**Nomination Form
Anadromous Waters Catalog**

Anadromous Waters Catalog Number of Water Body 182-70-10100-2022-3011

ADDITION and ROUTE CORRECTION

Nom #25-550

Figure 4.—182-70-10100-2022-3011 route correction and addition map.

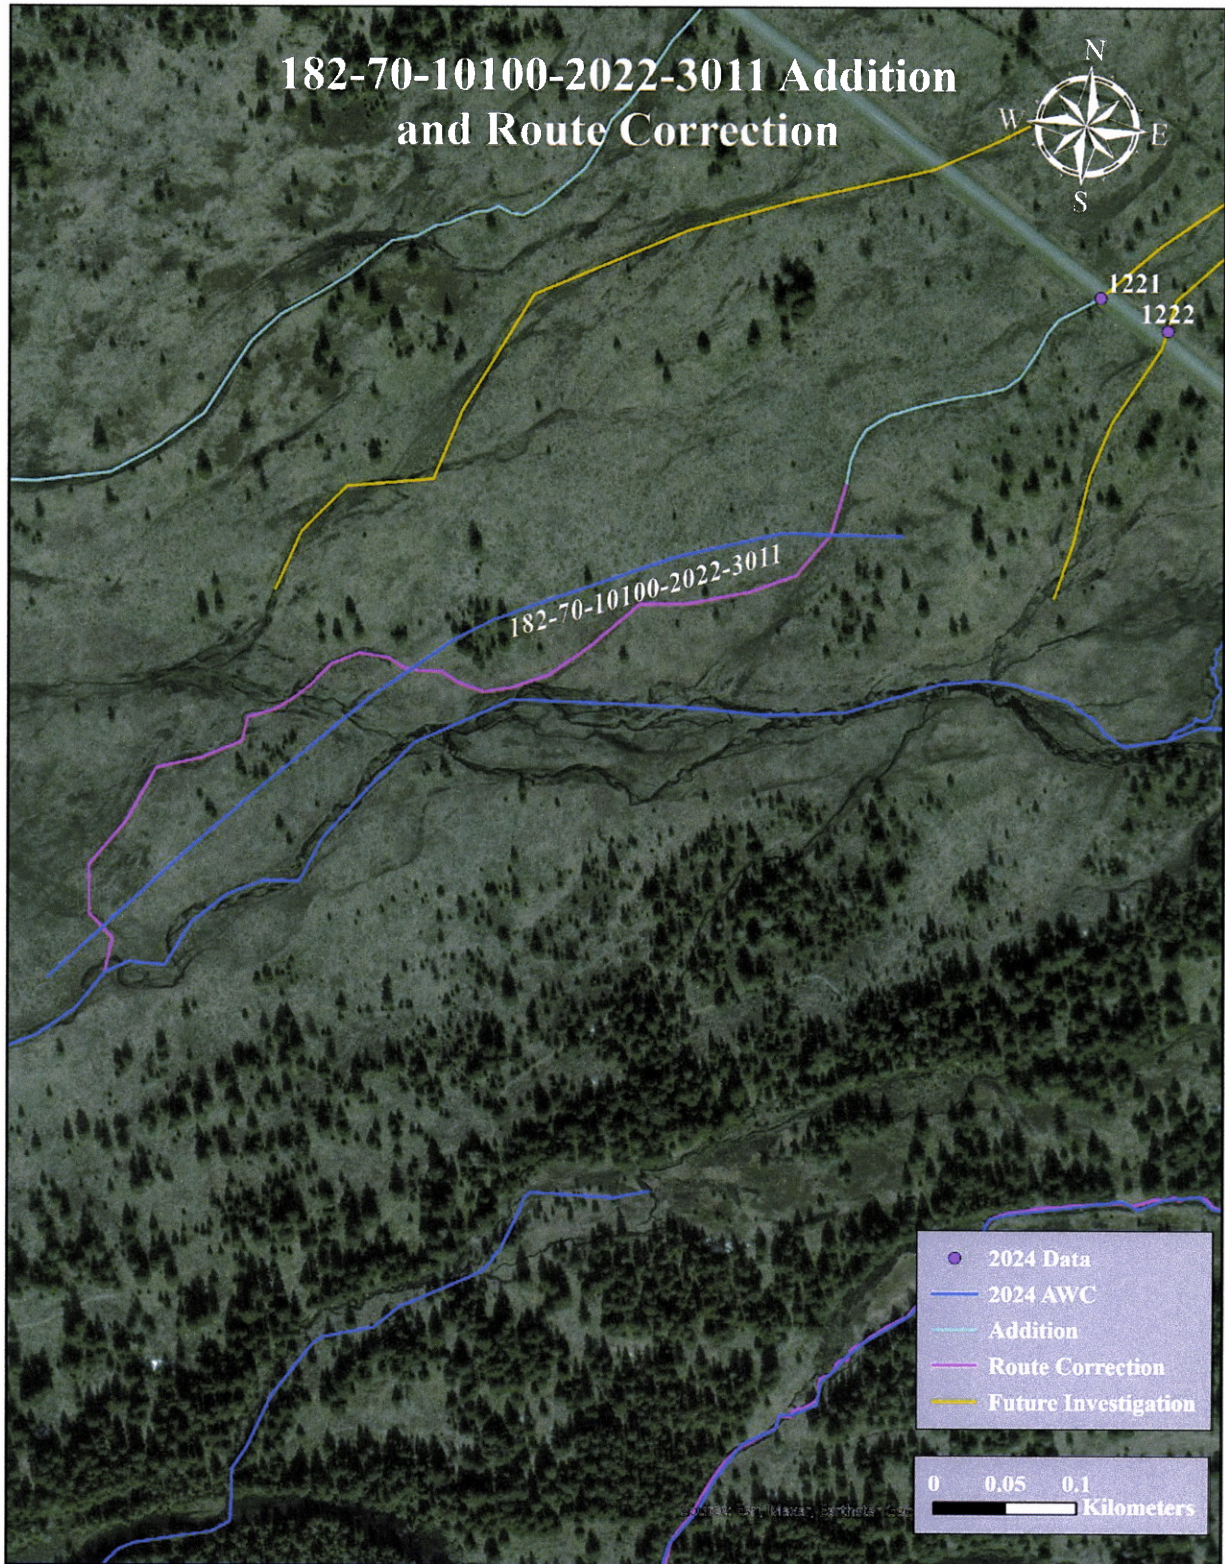
Recommendations: Correct Stream No. 182-70-10100-2022-3011 in the anadromous waters catalog to reflect the field verified stream path and extend the upper reach to waypoint 1221 (Figure 4).

Map #1

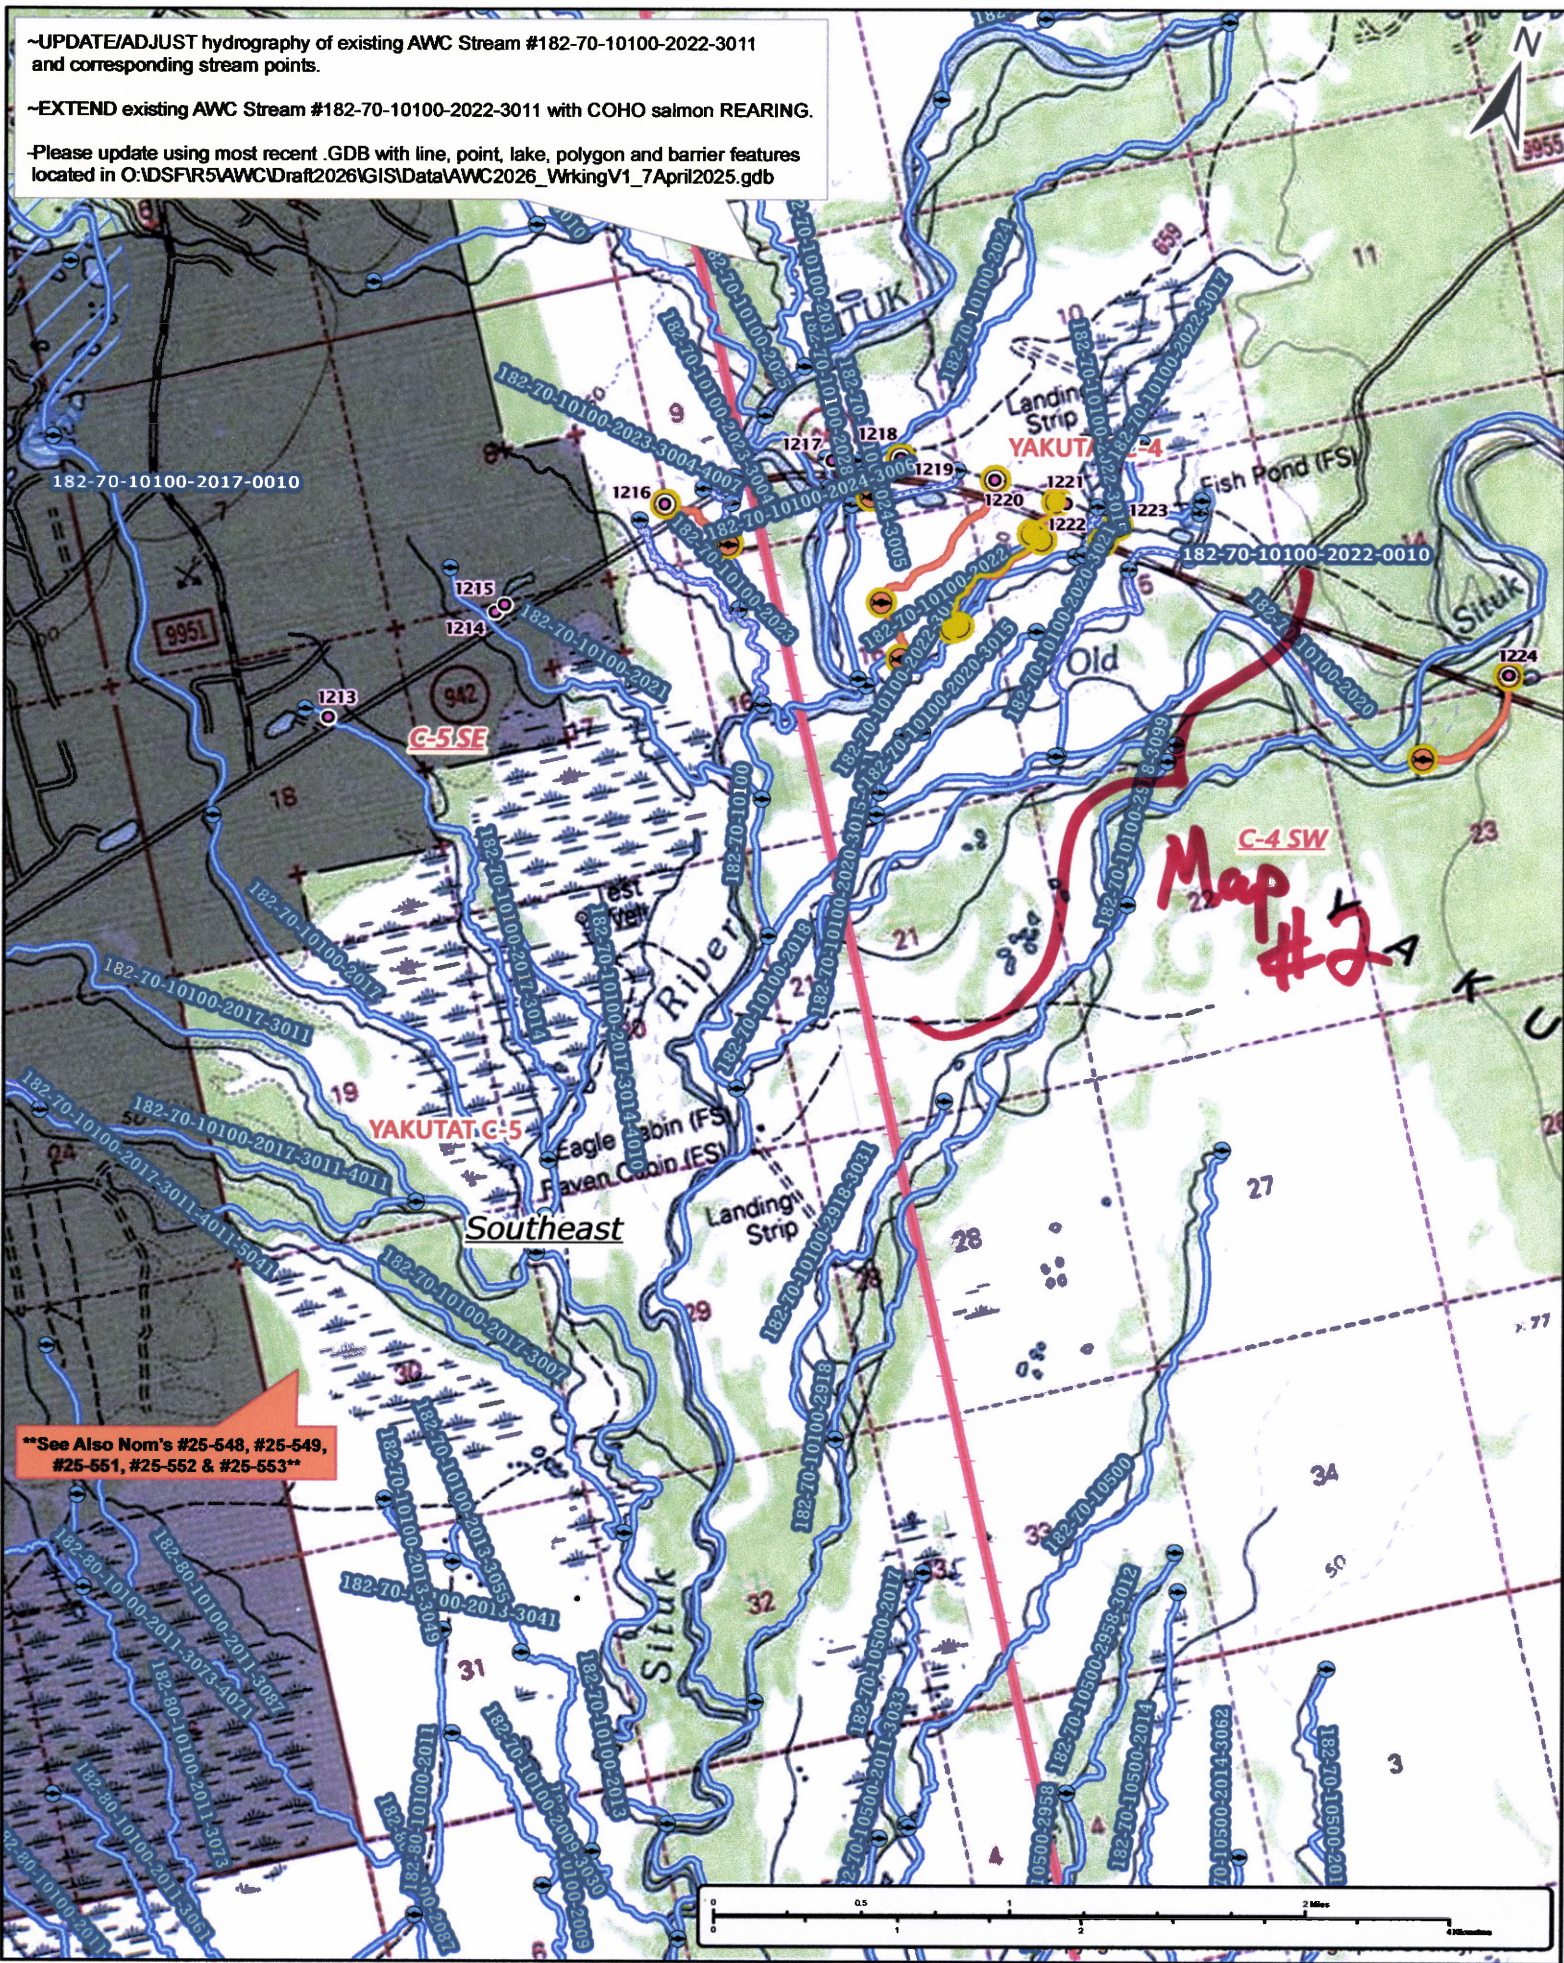
~UPDATE/ADJUST hydrography of existing AWC Stream #182-70-10100-2022-3011 and corresponding stream points.

~EXTEND existing AWC Stream #182-70-10100-2022-3011 with COHO salmon REARING.

~Please update using most recent .GDB with line, point, lake, polygon and barrier features located in O:\DS\FR5\AWC\Draft2026\GIS\Data\AWC2026_WrkingV1_7April2025.gdb

Map #3

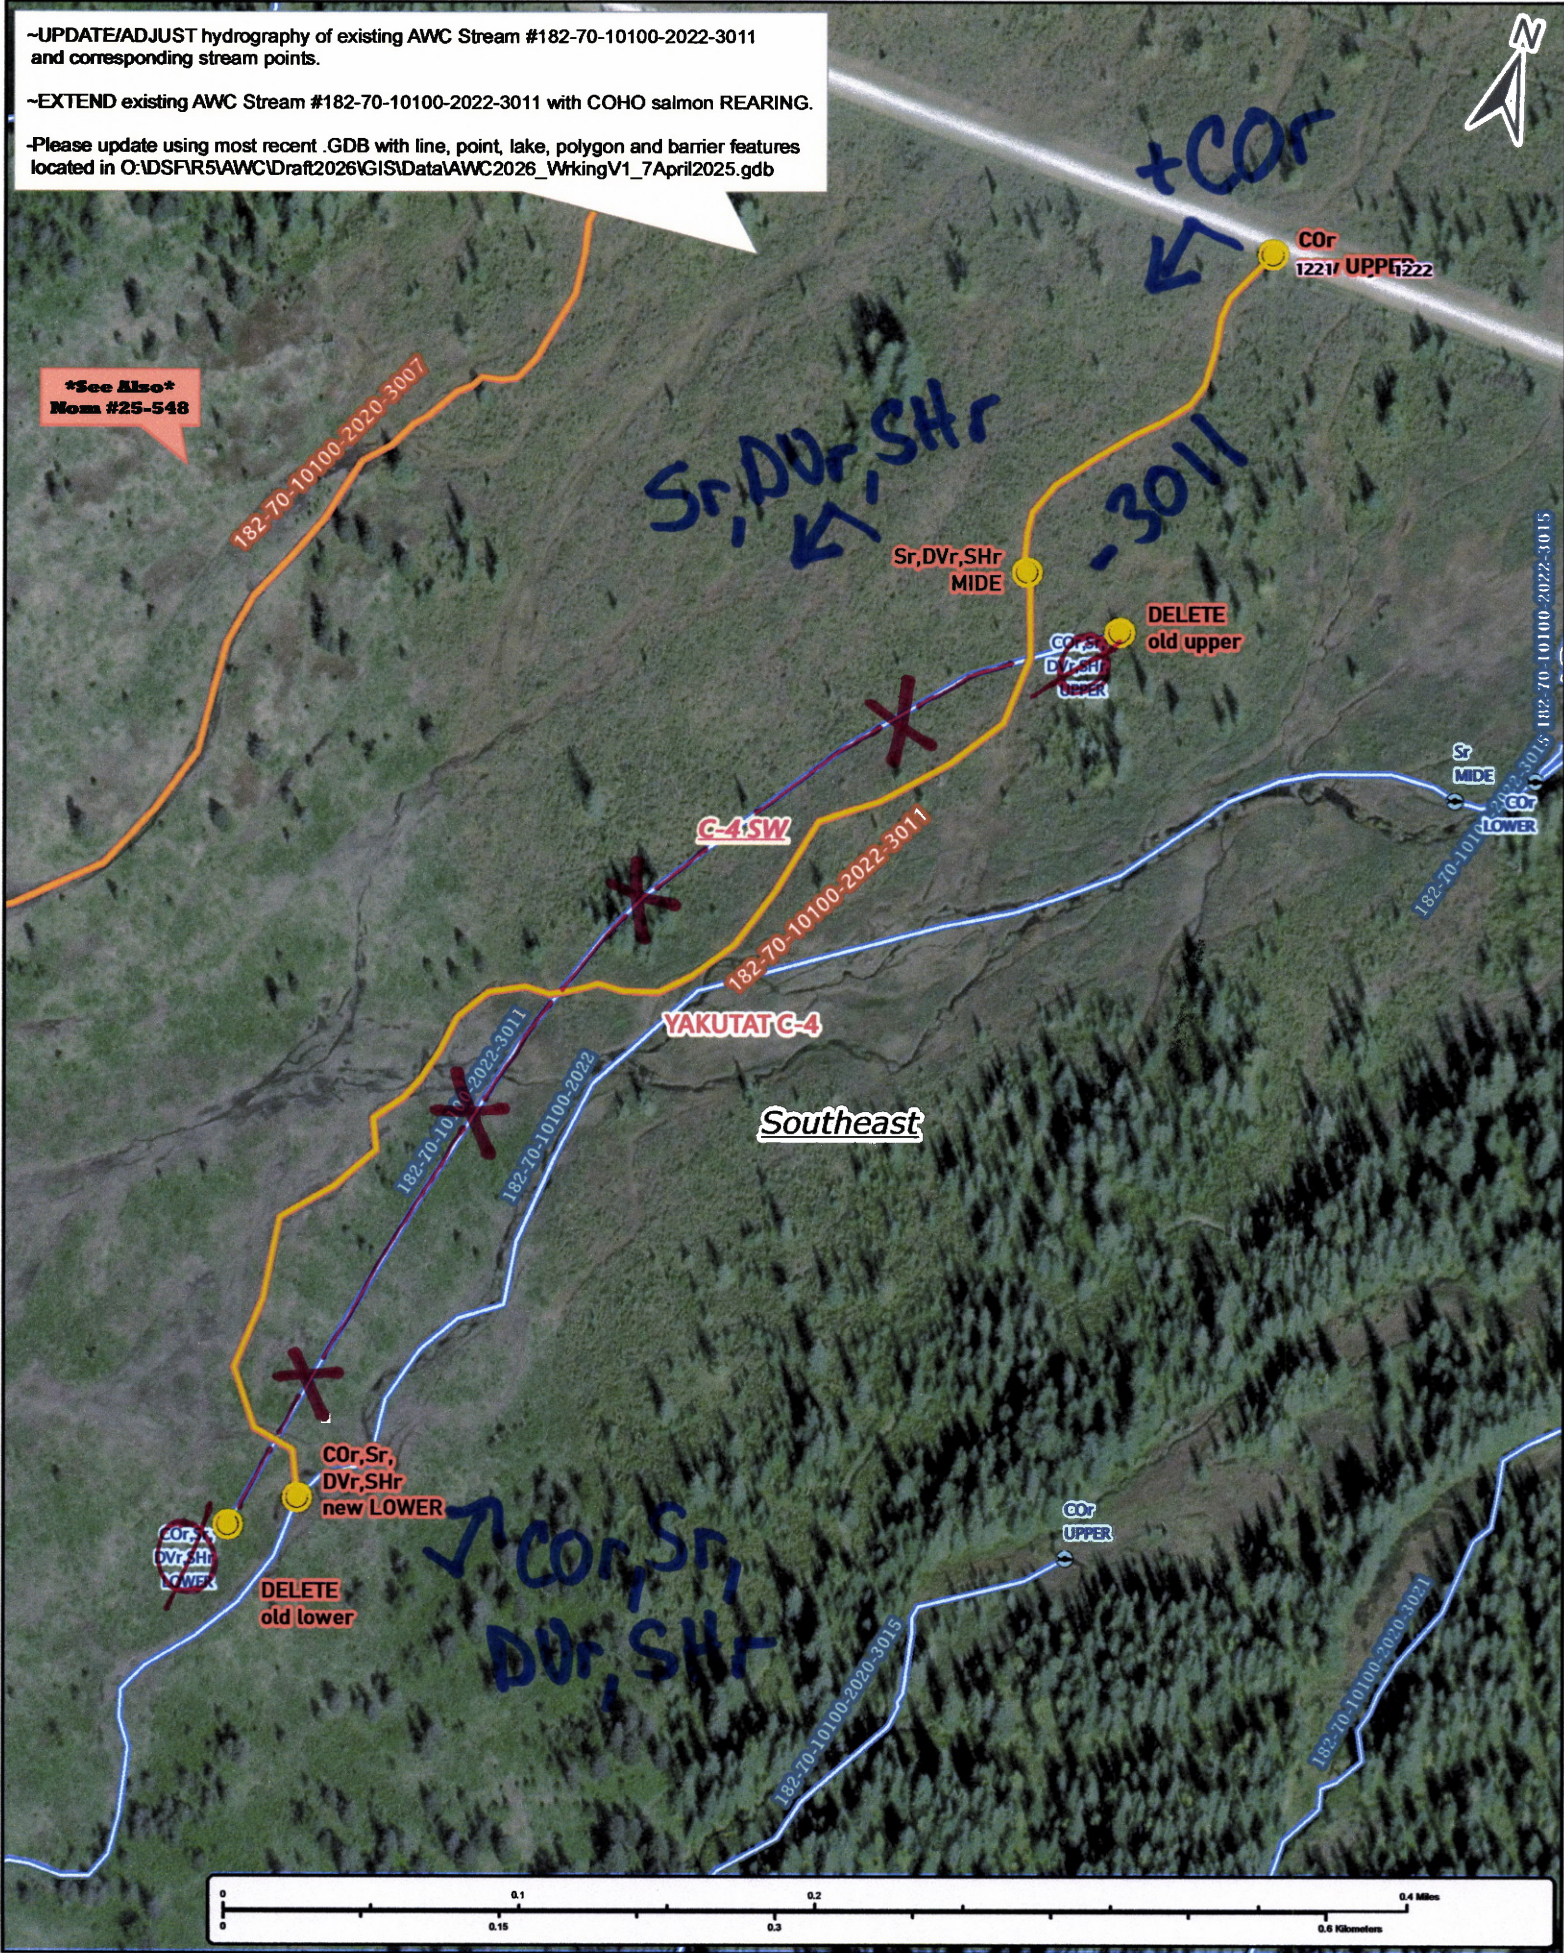
-UPDATE/ADJUST hydrography of existing AWC Stream #182-70-10100-2022-3011 and corresponding stream points.

-EXTEND existing AWC Stream #182-70-10100-2022-3011 with COHO salmon REARING.

-Please update using most recent .GDB with line, point, lake, polygon and barrier features located in O:\DSFR5AWC\Draft2026\GIS\Data\AWC2026_WrkingV1_7April2025.gdb
